Service Information Bulletin

SUBJECT	DATE
SPN 3031/FMI 3, 4 (ACM) (EPA10 - GHG14)	February 2014

Additions, Revisions, or Updates

d150245

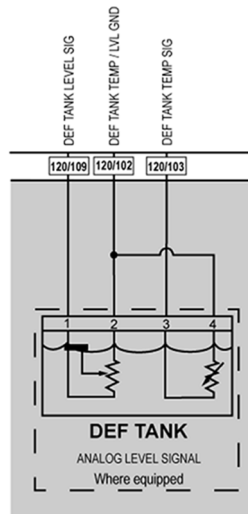
Publication Number / Title	Platform	Section Title	Change
DDC-SVC-MAN-0084	DD Platform- ACM - EPA10 - GHG14	SPN 3031/FMI 3 - EPA10 - GHG14	Diagnostic procedure has been updated; the wiring diagram and connector pin out have been added.
		SPN 3031/FMI 4 - EPA10 - GHG14
